From: Scala, Mary Joy
Sent: Friday, October 23, 2015 9:50 AM
To: andrew@corecville.com; 'Robert Nichols'
Subject: BAR Action - 550 East Water Street - October 20, 2015

Certificate of Appropriateness Application

BAR 15-10-08
550 East Water Street
Tax Parcel 530162300
Neal Sansovich, Owner/ Andrew Baldwin, Applicant
New Mixed-Use Complex

**CITY OF CHARLOTTESVILLE
BOARD OF ARCHITECTURAL REVIEW
STAFF REPORT
October 20, 2015**

Charlottesville
Sanborn Map
February 1920
Sheet 3
Notice the King
building in the
bottom right corner

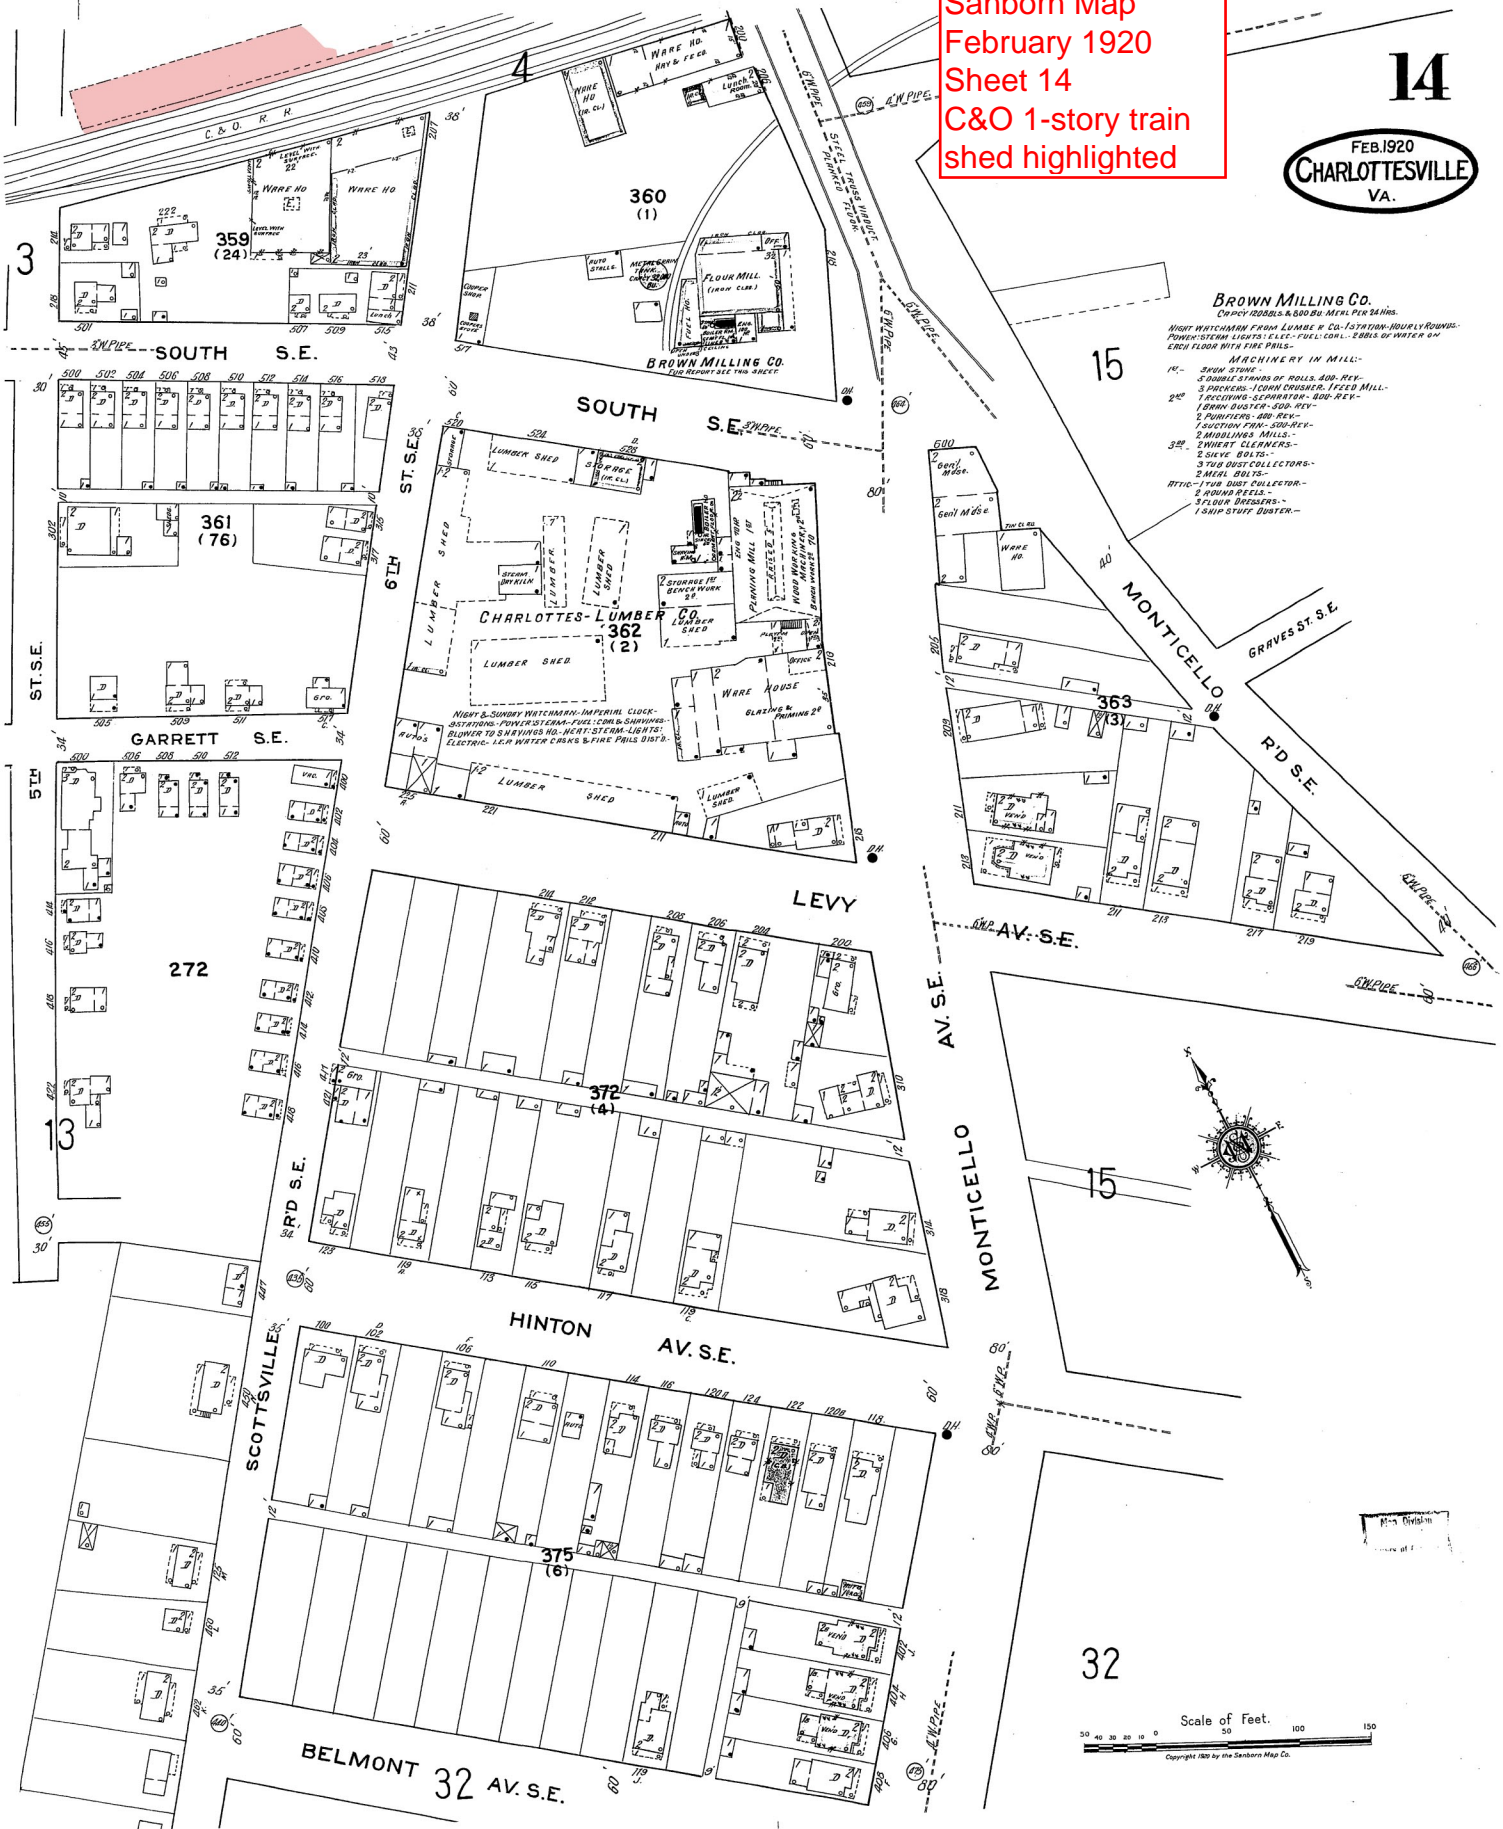
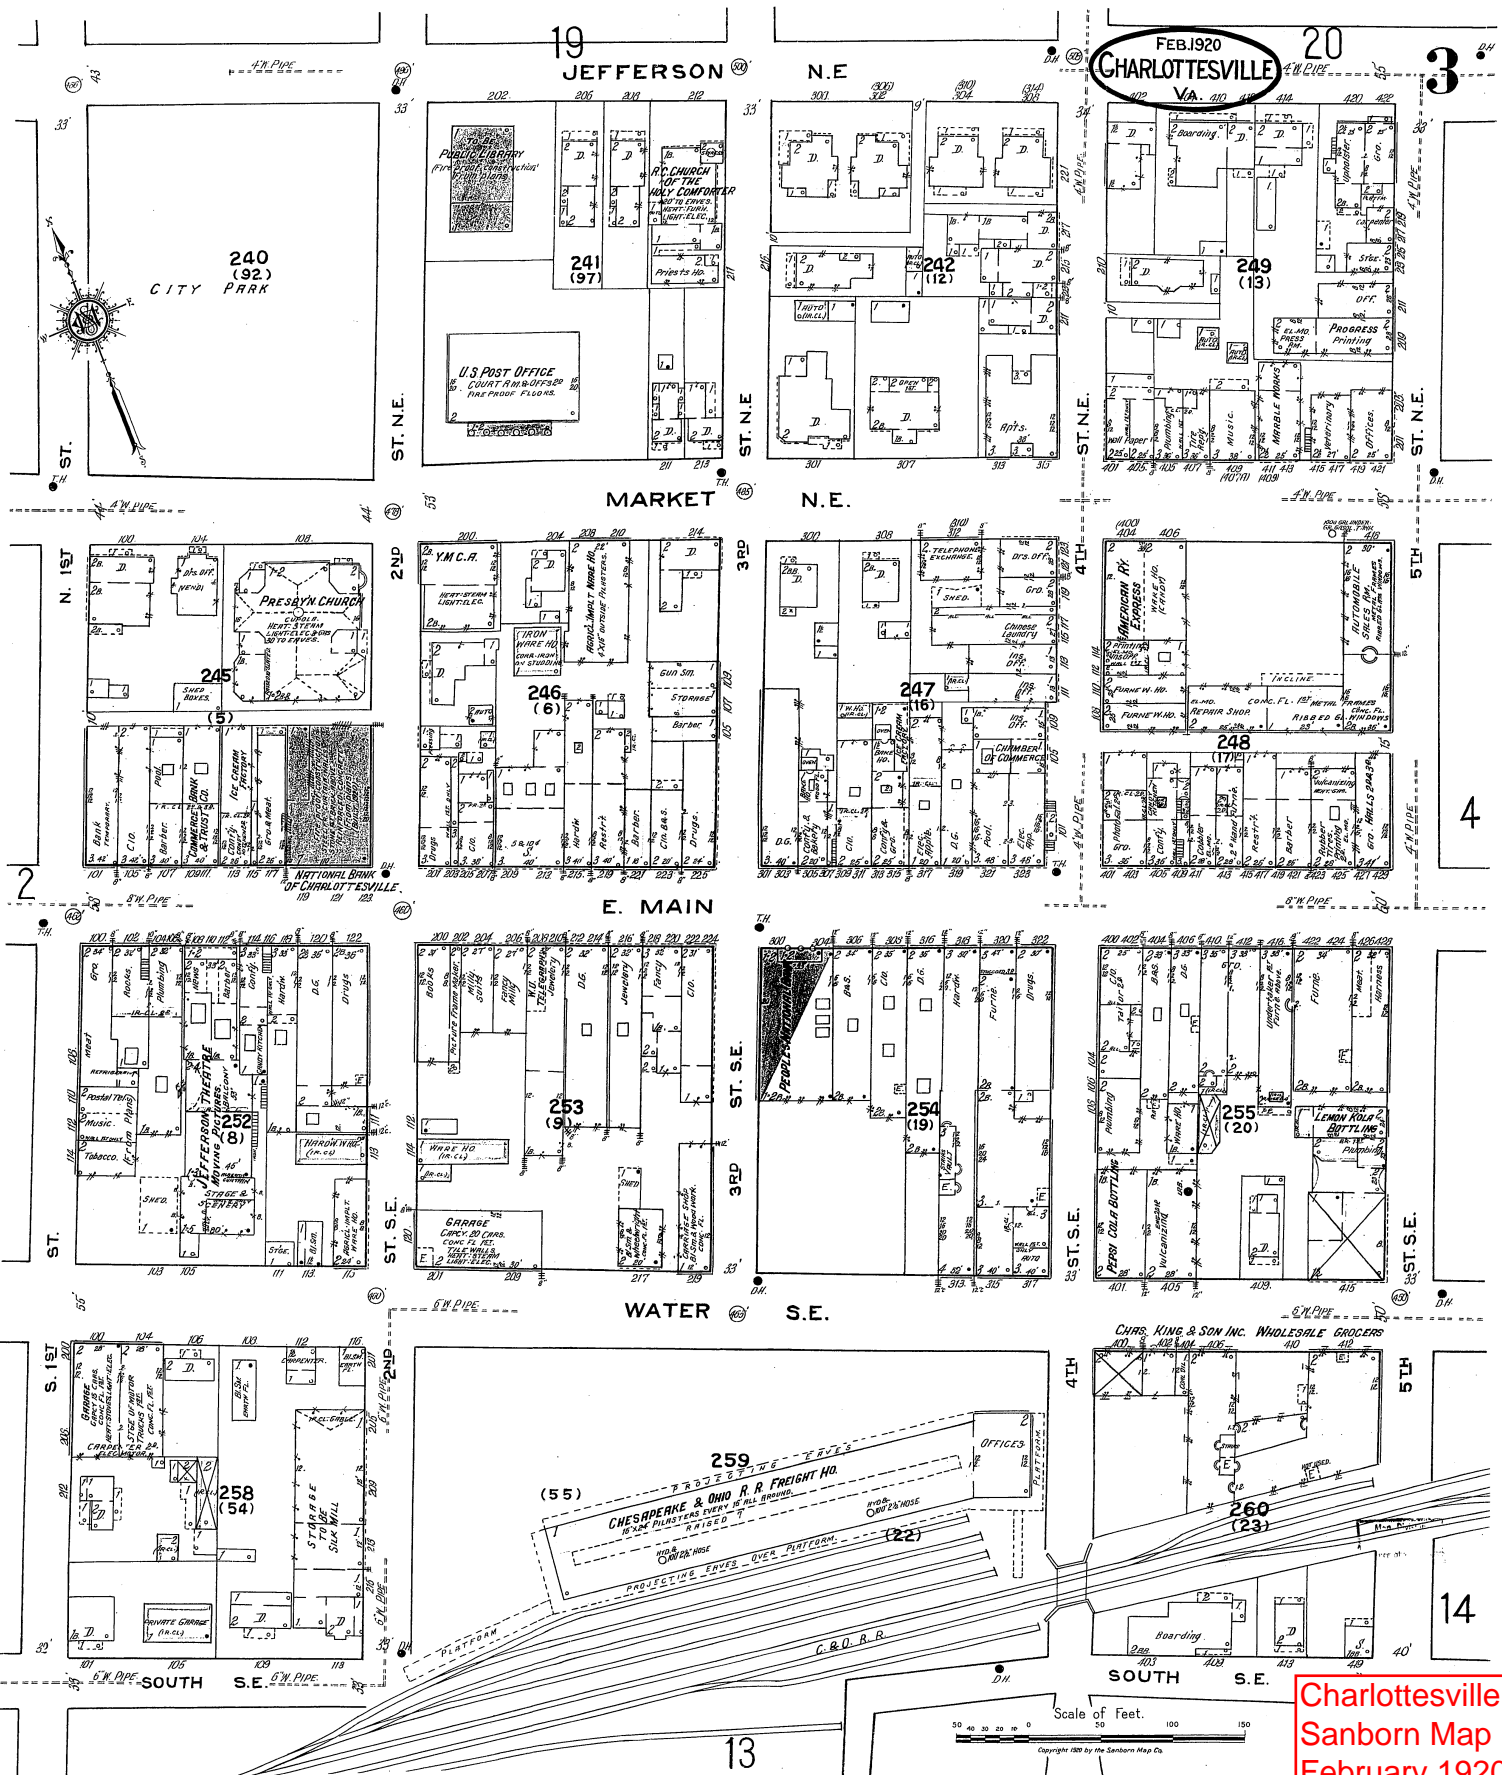
As the neighborhood developed by 1920, the sensitive scale and open massing of the train shed continued to coexist harmoniously with the surrounding buildings (Sheet 3, 4, and 14). These maps show the horizontal expanse of the train shed surrounded by low density, multi-use structures, including two-story dwellings on 5th Street SE and Water Street, a three-story warehouse on the other side of the iron viaduct that arched over the tracks, and two-story dwellings and warehouses across the tracks.

550 WATER ST MIXED-USE NORTH ELEVATION

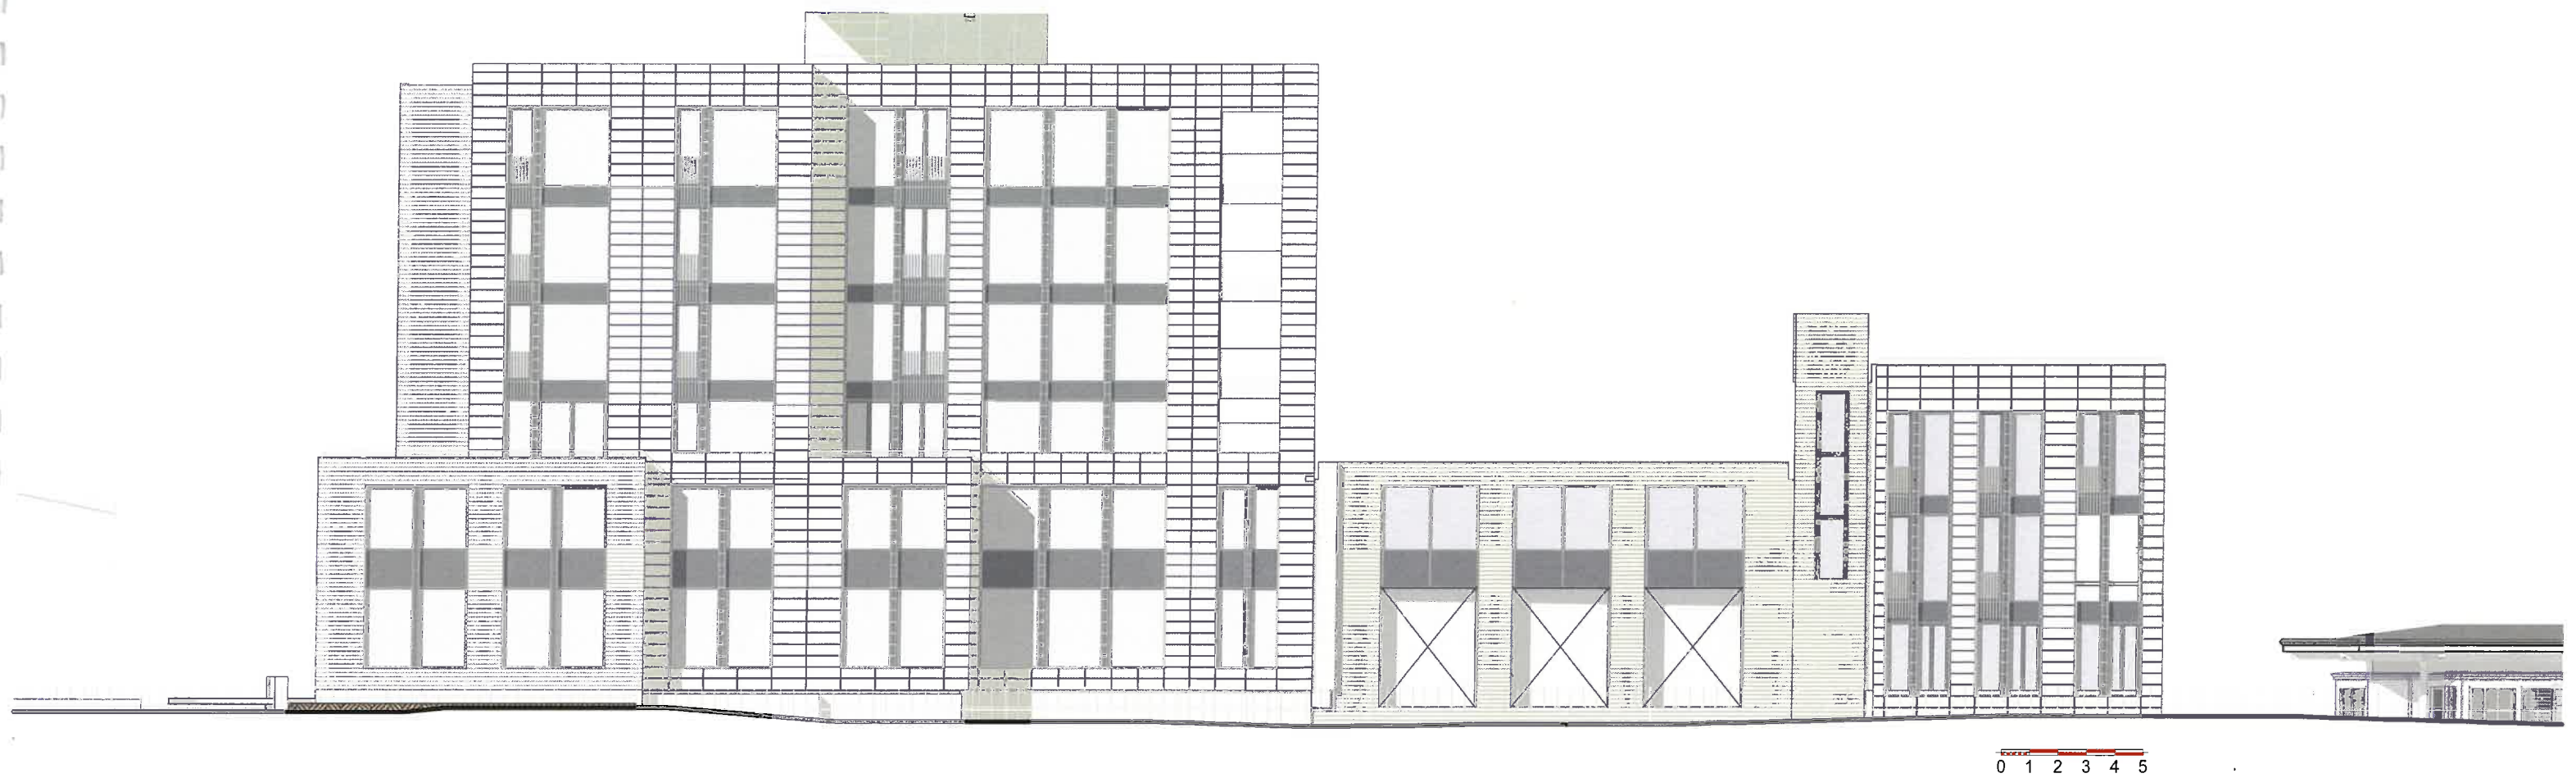
Since the last review, the applicant has included north and south elevations as well as expanded elevations to show its *relation to the buildings on either side*. The BAR should focus on how the new construction interacts with the buildings on either side as well as the streetscape and pedestrian experience of East Water Street. The proposed design minimizes the impact of the garage openings, and includes along Water Street entrances to two commercial spaces, and a stair egress door.

only. The current design correctly shows the maximum height called out to be 70 feet, measured to the flat roof, although the scale on the drawings is incorrect. The BAR should ask to see the west elevation included with future plans.

The drawings suggest that there is some sort of mechanical structure atop the building that exceeds the 70-foot height restriction. Is that allowed?
